Council Meeting - Agenda Item 9.3 - Attachment 2 - Plans to be Endorsed
 2 Glenelg Street, South Launceston - 12 August 2021

DA0338-2021 – CARPORT AT 2 GLENELG ST

A. RESPONSES TO SUBMISSIONS for DA0338-2021

9am 21 June 2021

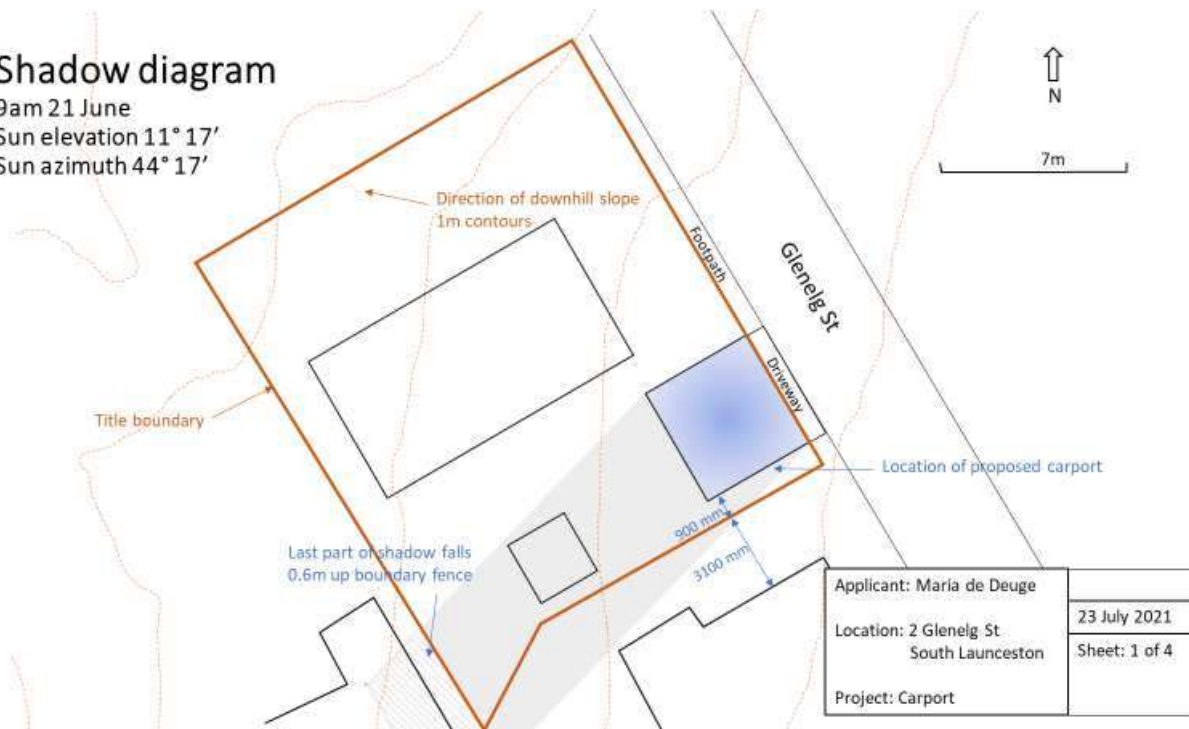
SUBMISSION	RESPONSE
My main concern is regarding the height of the structure and its potential to cause shading for the residence at This is of great concern as it will decrease the amount of light and sun into this residence and potentially cause problems with moss and mould growing on this house. It is so important for a home to receive natural light and it will create a greater burden on heating this house, which seems unfair especially in these times when climate change and the need to reduce energy consumption is so important. If the height of the proposed structure was reduced this would help mitigate the potential problems and consequences of shading and light reduction. .	<p>The potential for shading of adjoining properties is described in section 1. <i>Shading and Natural Light</i>. Shading diagrams are enclosed below under section B. <i>SHADOW DIAGRAMS</i> below.</p> <p>The proposed carport has negligible effect on the natural light and shadowing of the adjacent properties because the minimal amount of shadowing that would occur is already caused by the banister and surrounding vegetation.</p>

It was suggested that the proposed carport will reduce natural light to and cause shadowing of the adjacent property, leading to dampness and mould. Shadow diagrams were produced for 9AM, 12 noon and 3PM for the shortest day of the year, 21 June (see section C Shadow Diagrams below). At 9AM, the maximum shadowing only came up to 0.6m on the boundary fence with 22 Eardley Street. At 12 noon, the shadow fell across the boundary fence to 20 Eardley Street. If the wall of this dwelling were unobstructed, the shadow would fall 0.8m up the dwelling wall, well below window height. However, this wall is currently obstructed by an attached staircase banister thickly covered in vines, and trees on the boundaries, so it is already in shadow from these (see photos below). At 3PM, the shadow falls on the easternmost 1.8m of the dwelling, where there are no windows.
